Subject: Payzant Drive / Wentworth Road Roundabout Design

Council approve the award of tender WHRMPW24-03 for Construction of the Payzant Drive/Wentworth Road Roundabout to the low compliant bidder, Dexter Construction, for the tendered price of \$4,274,980.00 plus applicable taxes. And, council also approves a construction contingency of 15% (\$641,247) and the cost for overhead utility relocation, for a total construction estimated cost of \$5,116,227 plus applicable taxes.

PAYZANT DRIVE ROUNDABOUT WINDSOR, NOVA SCOTIA

Addendum #2

Drawn J. DWYER	Engineer P. BURGESS	Project No. 21-435	Drawing No. C-TR02
Scale 1:250	Filename 21-435_TR01_EXISTING CONDITIONS.dwg	02 of 14

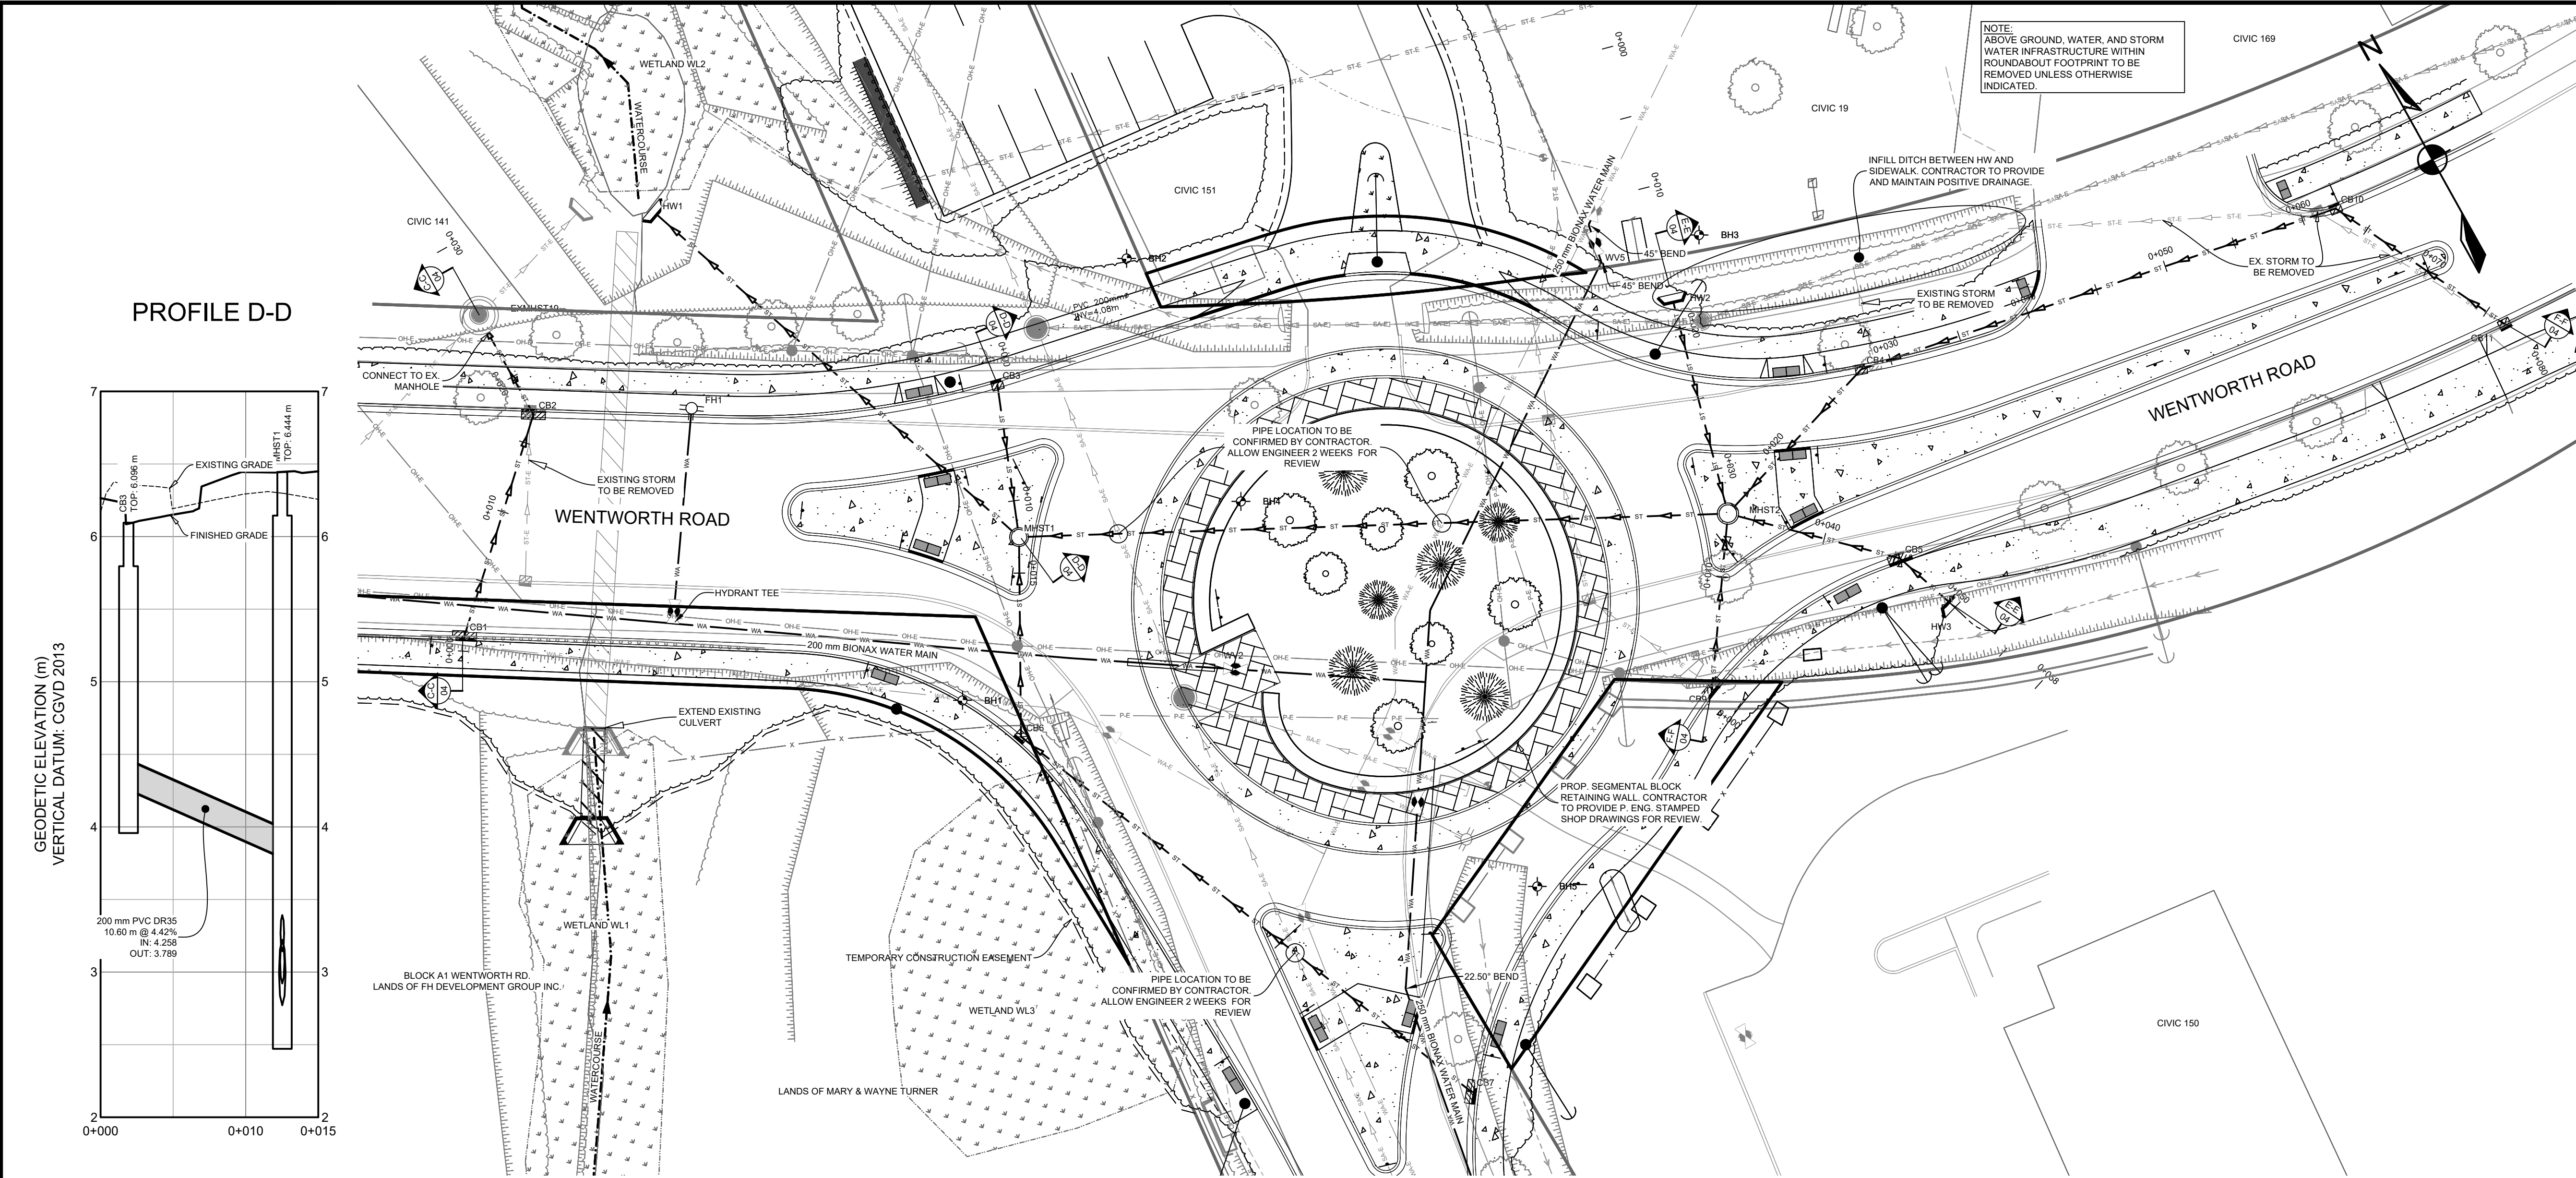
Question 5: The existing conditions plan provides no existing grading information. The grading plan provides very minimal existing grading information but is insufficient for use to calculate volumes. Can you please provide more detailed existing grading information?

Answer 5: See the updated existing conditions plan.

Drawn J. GALLANT	Engineer A. SKETCHLEY	Project No. 21-435	Drawing No. TR09
Scale N.T.S.	Filename 21-435_TR05_INT-WENTWORTH XS.dwg		09 of 14

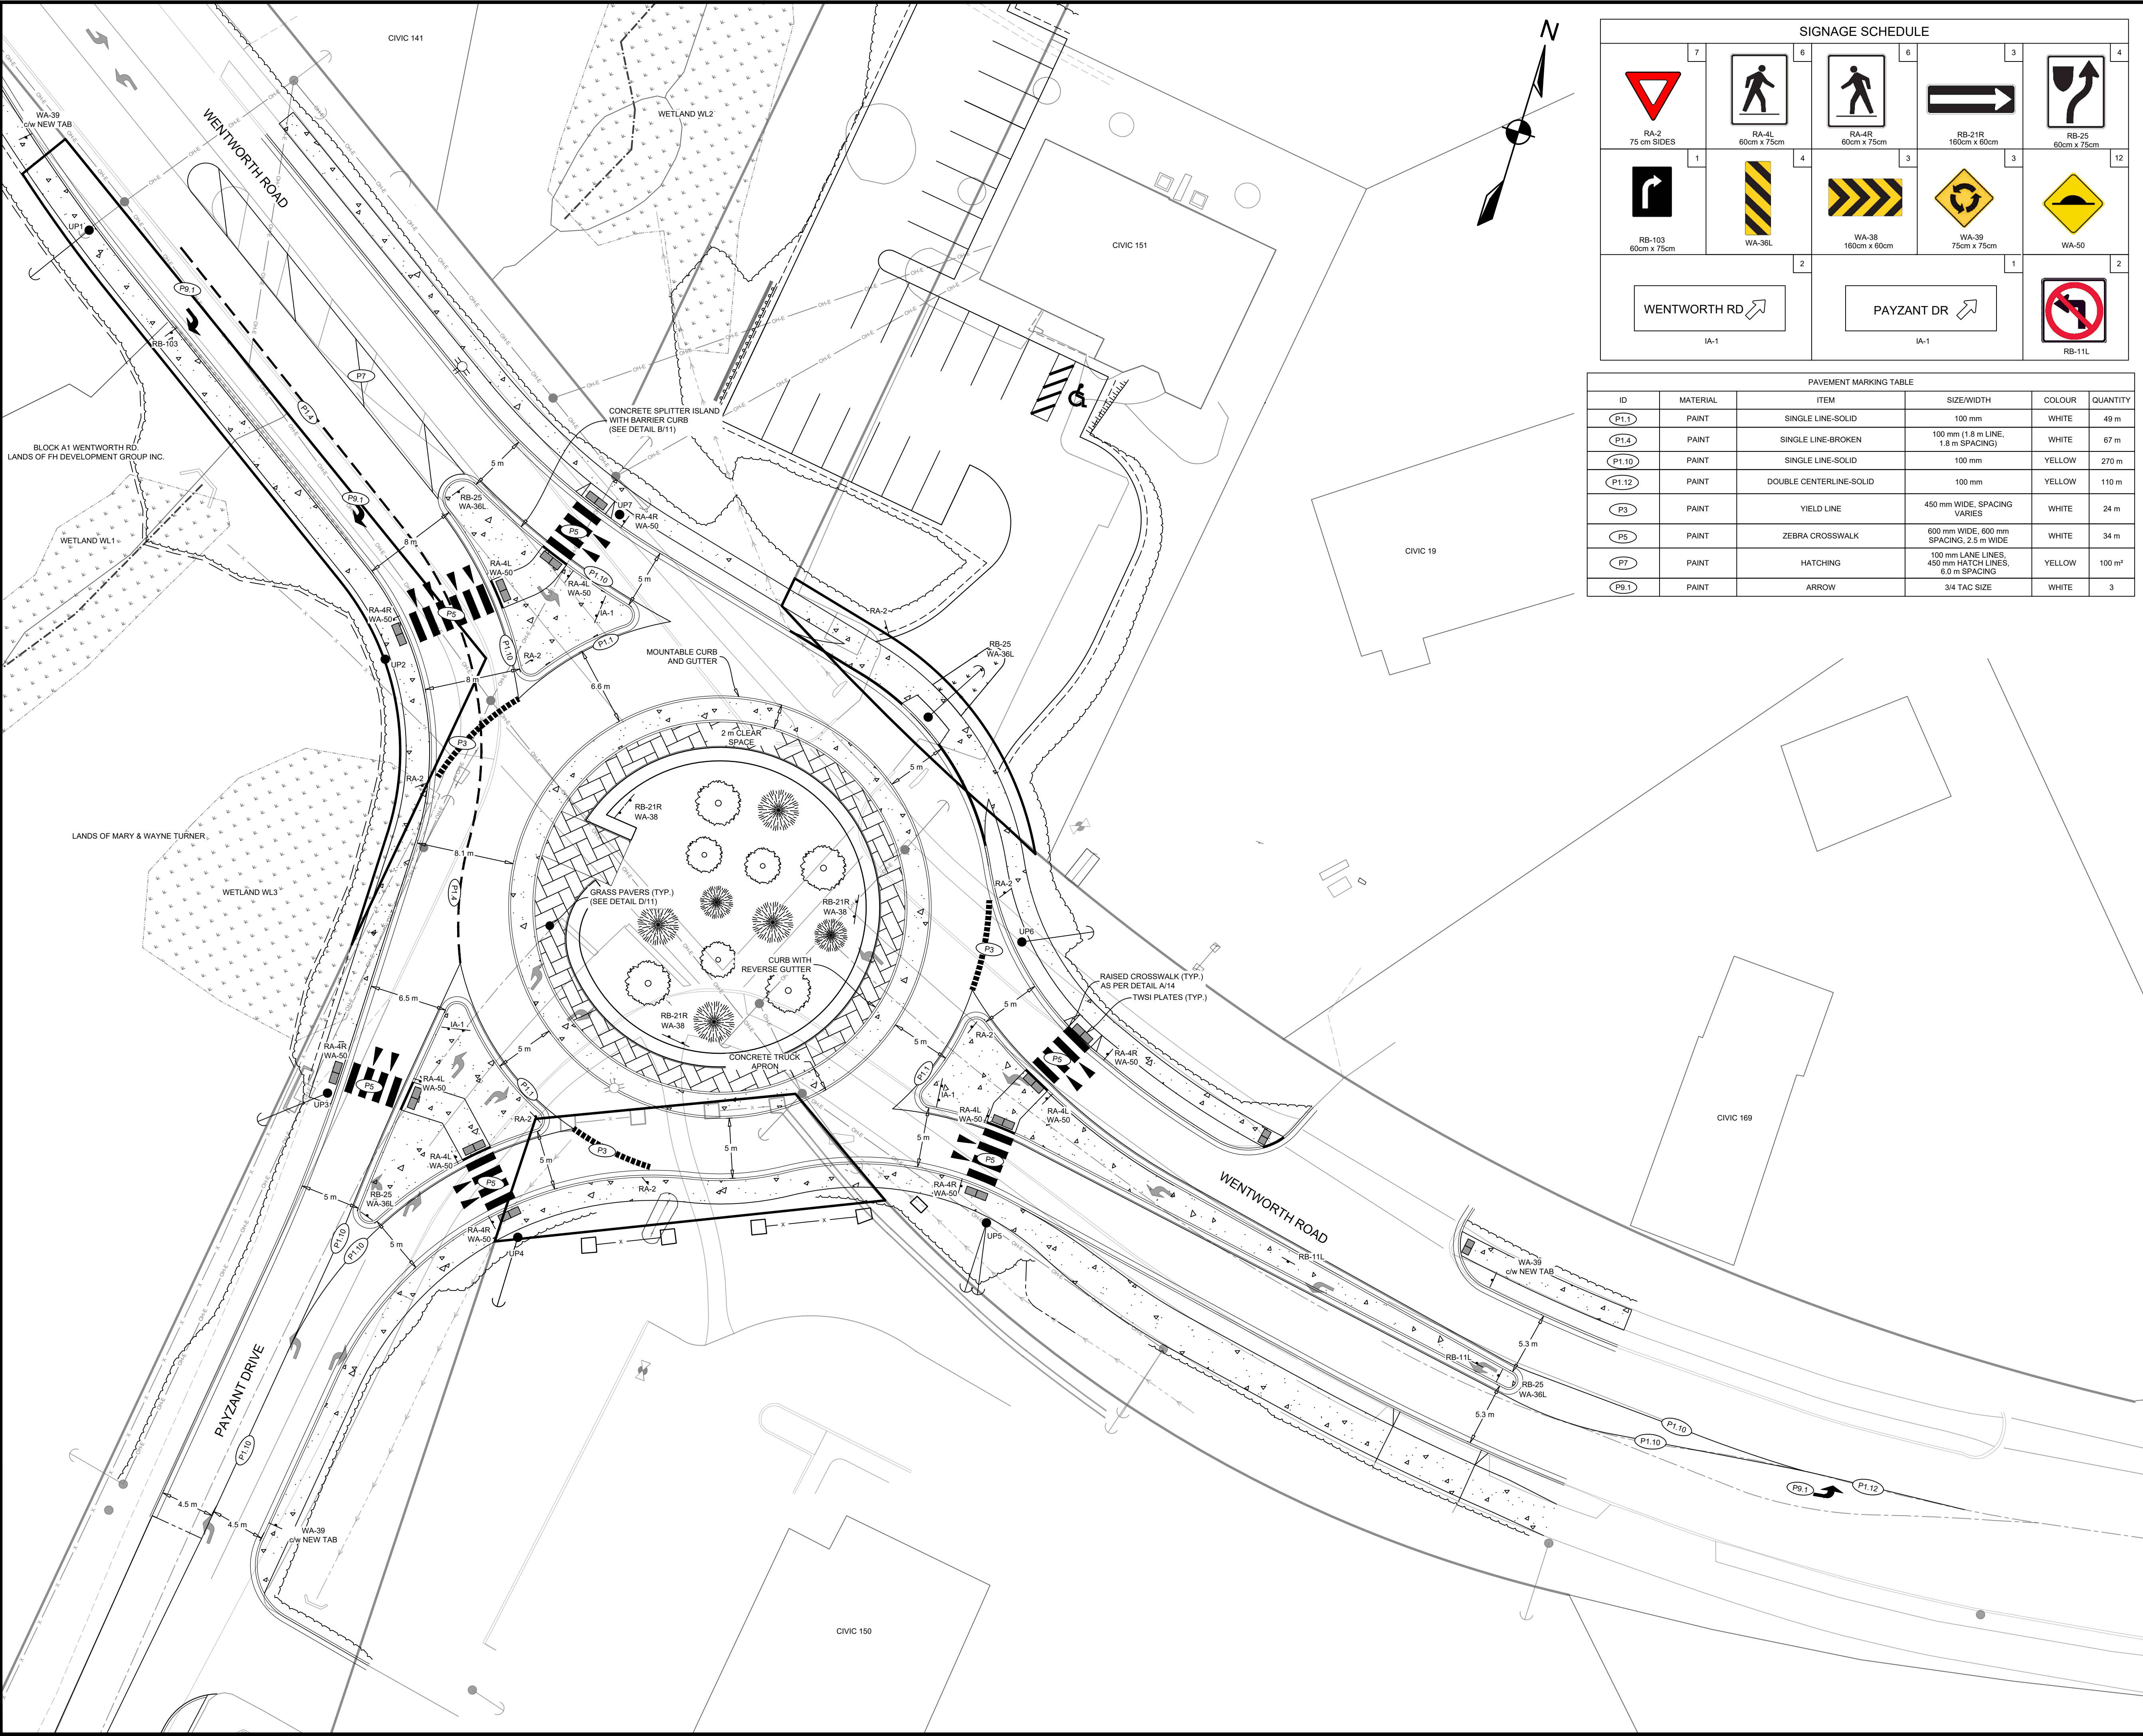
Question 1: The new road structure details (detail A-E) shown on drawing TR09 indicates prime is required on top of the Type 1 gravel. As discussed at the site meeting, this is atypical for projects like this and would be difficult to apply as traffic will be traveling over the gravels prior to paving. Can you please confirm that prime won't be required?

Question 2: The new road structure details (detail A-E) shown on drawing TR09 indicate geotextile is required under the new road structure on top of the subgrade. There isn't a pay item for this on the tender form. Could you please provide a pay item for this work?

Answer 1: Primer will not be required on top of the Type 1 gravel.

Answer 2: Geotextile is only required when placing surge rock on subgrade and has been added to the description of surge rock.

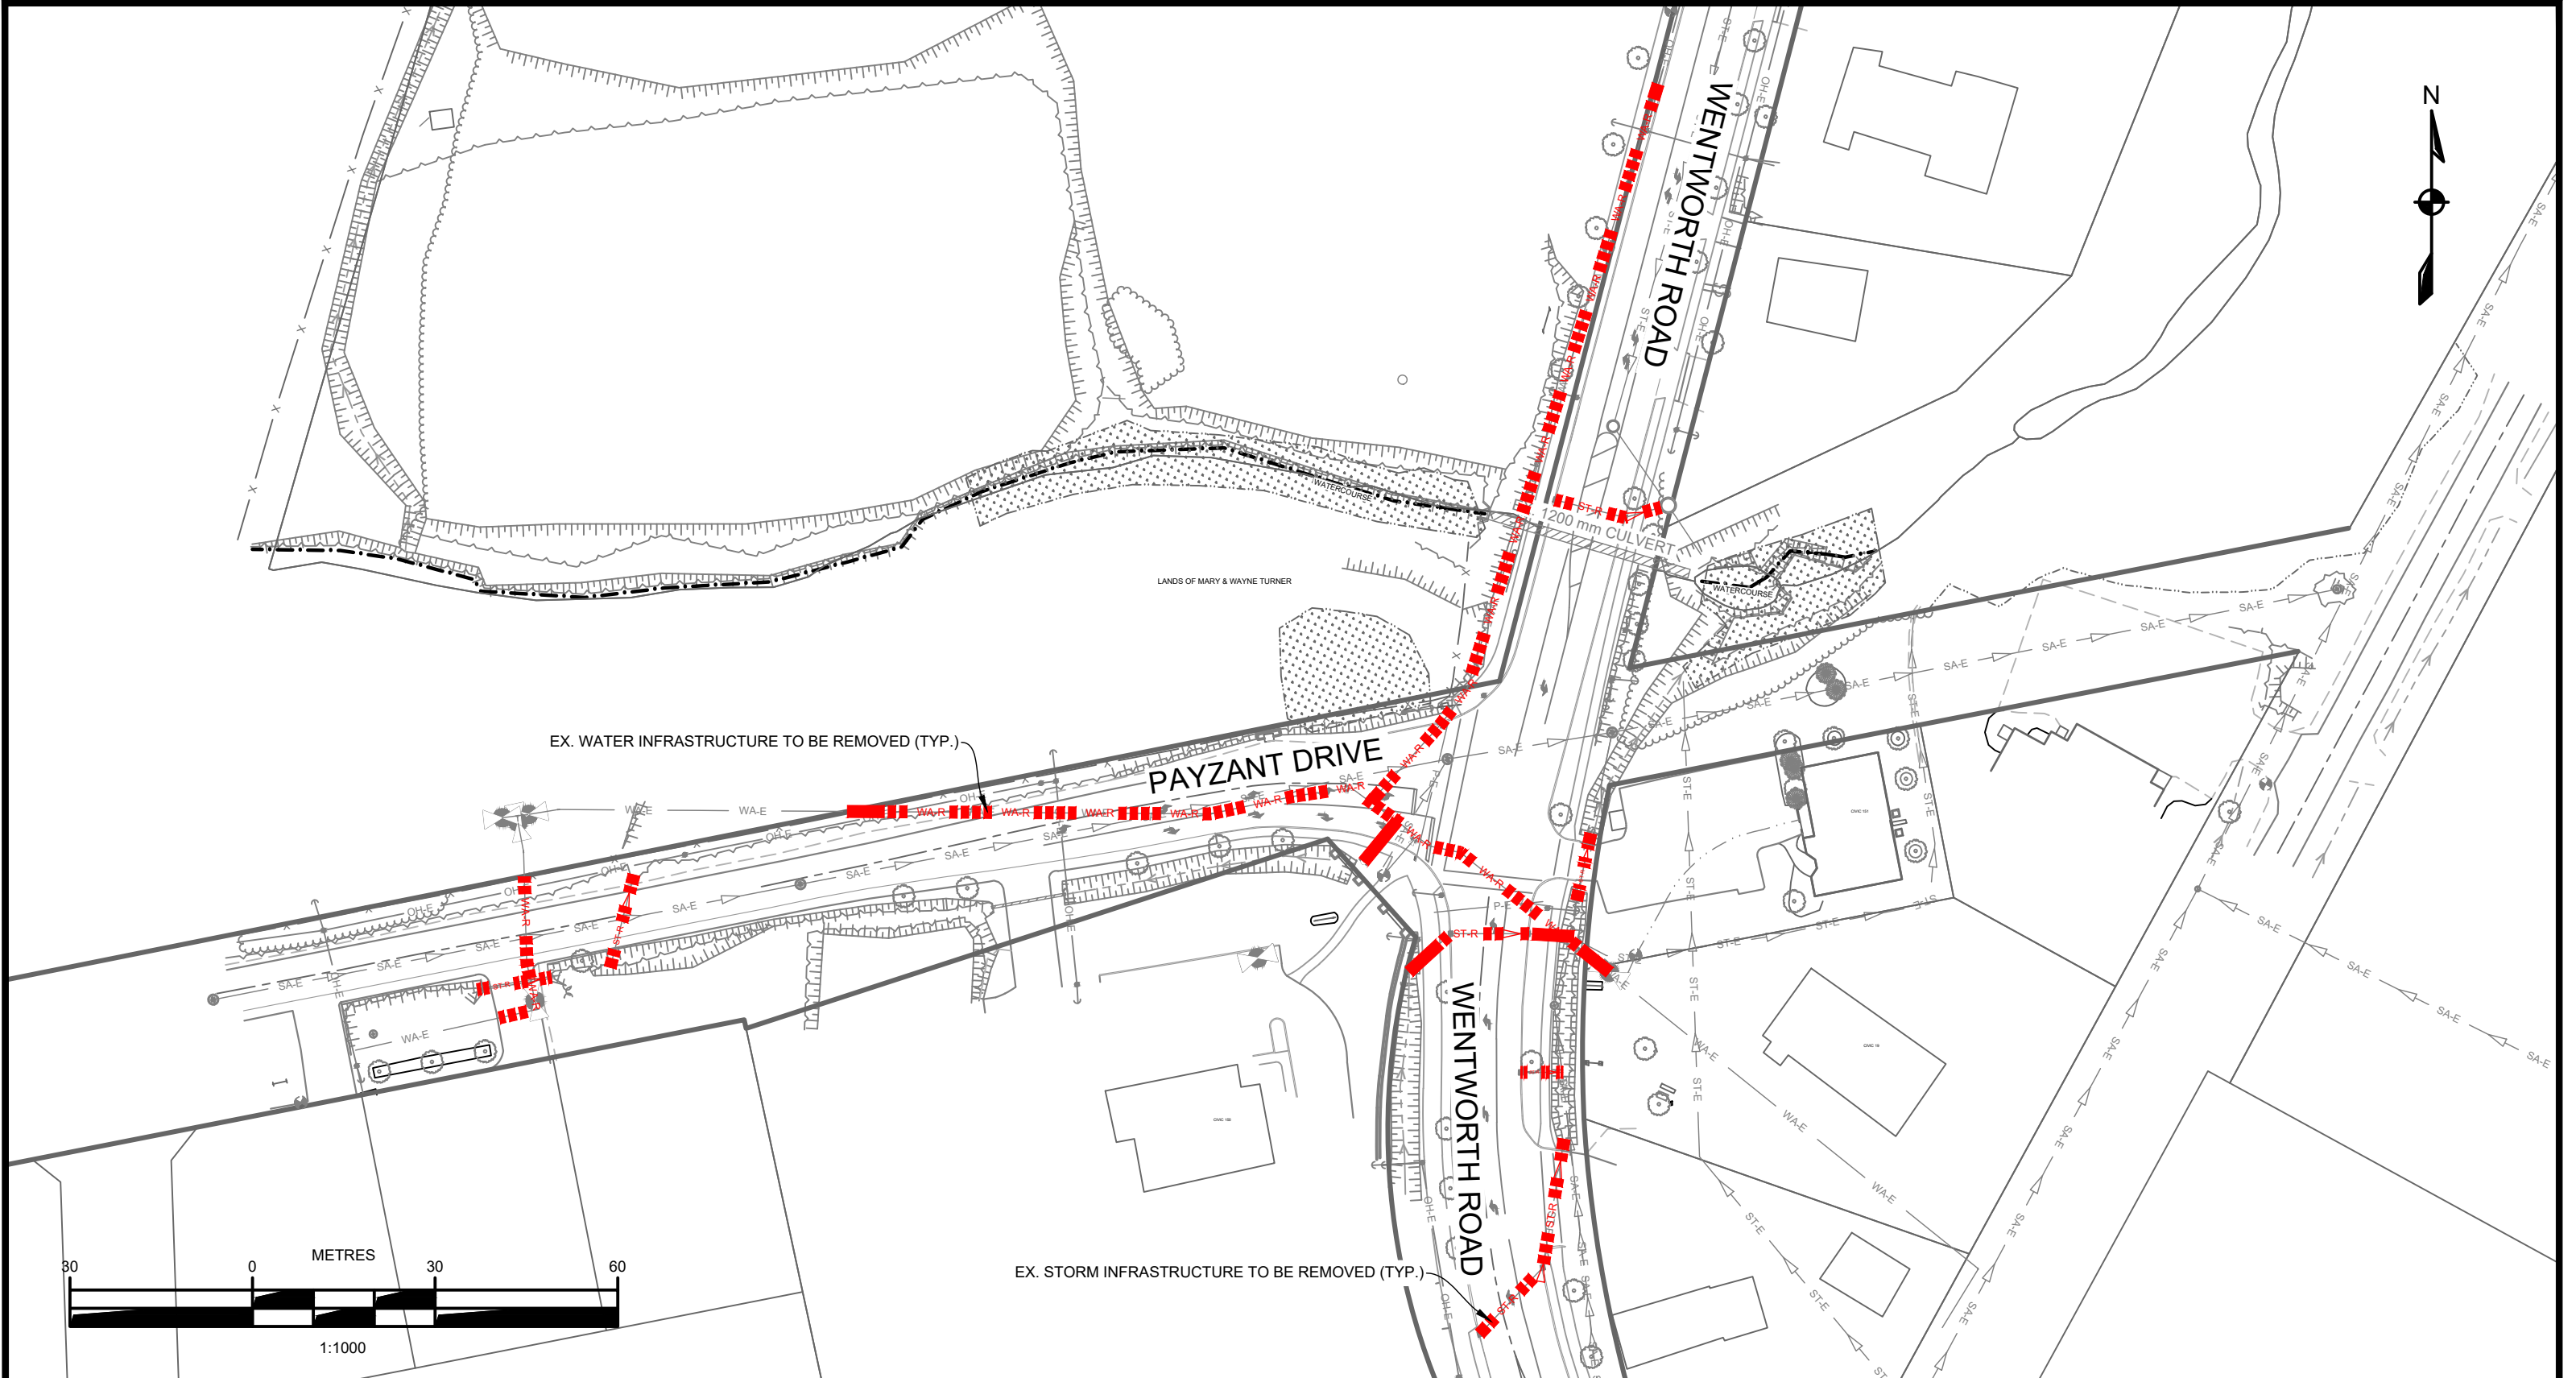
Question 11: It was mentioned at the site meeting that the existing buried infrastructure requires removal only in locations where it interferes with new buried infrastructure. On the drawings, it says to remove all buried infrastructure within the limits of construction. Please confirm we are only required to remove the existing buried infrastructure if it interferes with the new infrastructure. Also, further to the question we had submitted previously, please provide a separate removals plan so that removals can be accurately quantified.

Answer 11: See the attached removal plan.
